**MUDDY RUN II STREAM AND WETLAND RESTORATION  
PROJECT  
MONITORING REPORT  
MONITORING YEAR 4  
FINAL**

DUPLIN COUNTY, NORTH CAROLINA  
CONTRACT No. 004631 - PROJECT No. 95354

RE: Muddy Run II Stream and Wetland Restoration Site: MY4 Monitoring Report  
(NCDMS ID 95354)

Listed below are comments provided by DMS on January 17, 2018 regarding the Muddy Run II Stream and Wetland Restoration Site: Year 4 Monitoring Report and RES' responses.

< 5%

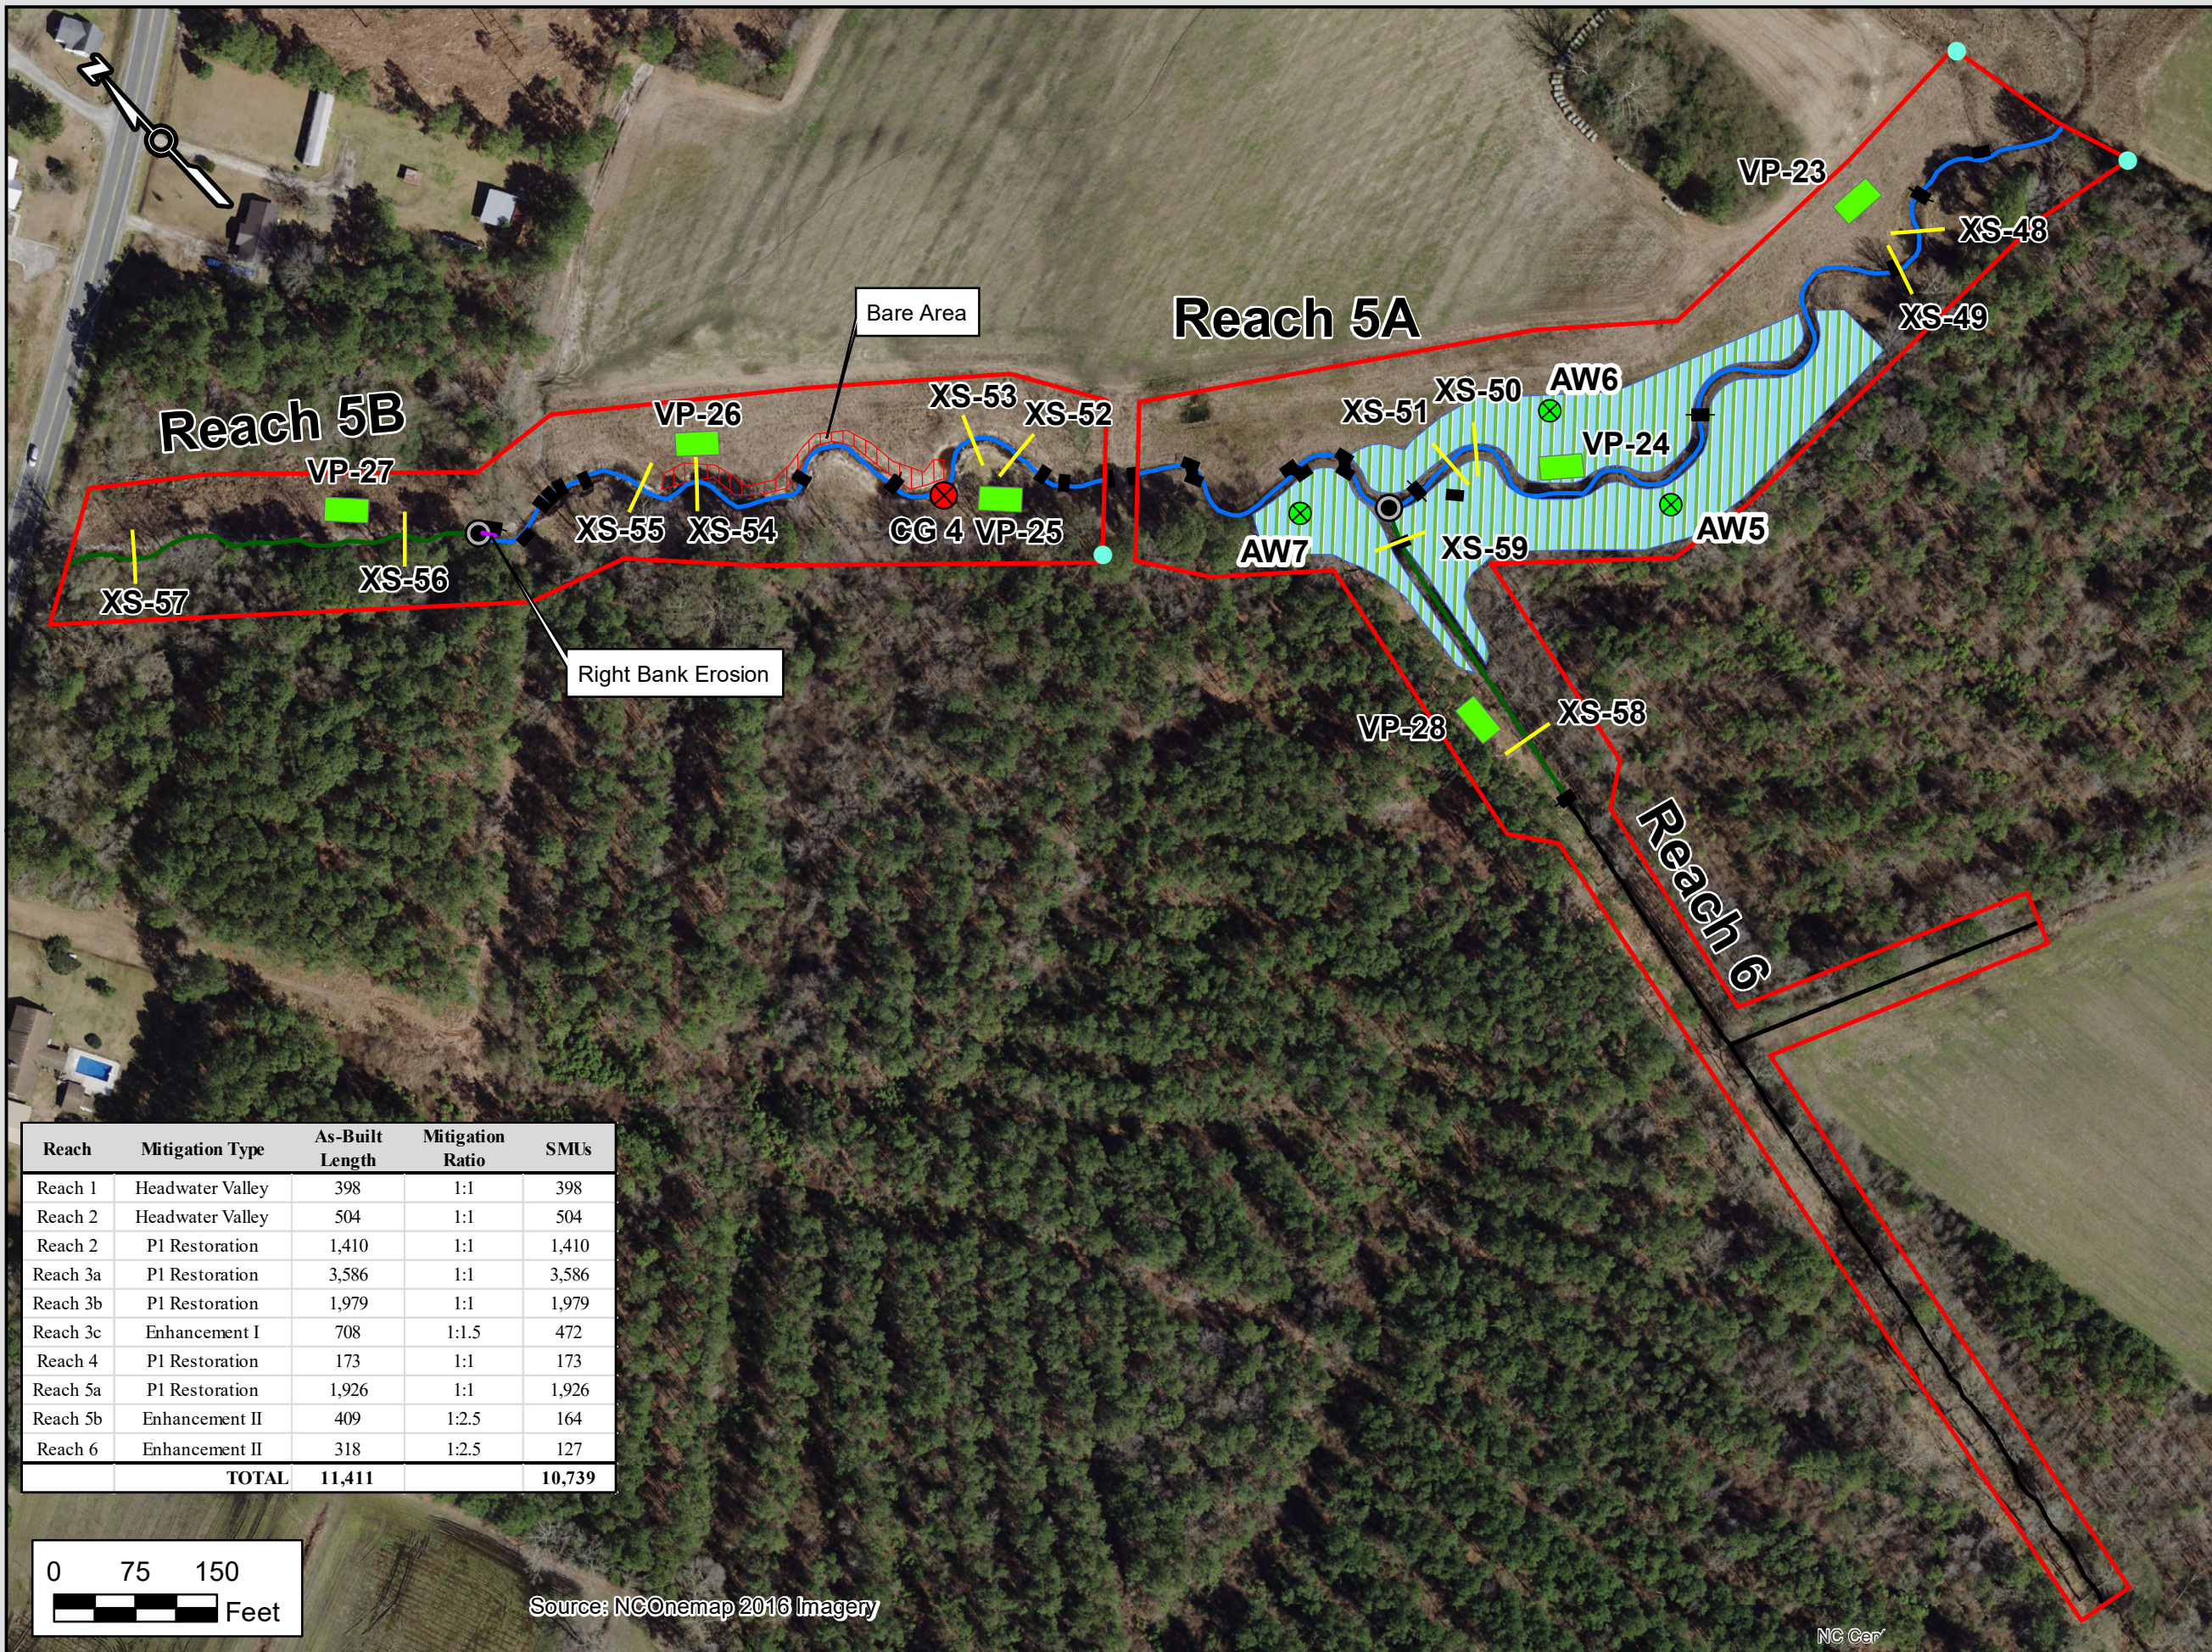
- b. Reach 6 credit: the map shows the upper portion of reach 6 as having EII credit, but the Mitigation plan shows this as a non-credit area. I think you could list the upper portion of this reach and the side channel as additional stream, not for credit. Please update CCPV.

The upper portion of Reach 6 (893 ft) and the side channel (307 ft) that confluences with it are now shown as “Channel – No Credit” on the CCPV and a footnote about them has been added to Table 1. Reach 6 is also discussed in Section 1.3.1.
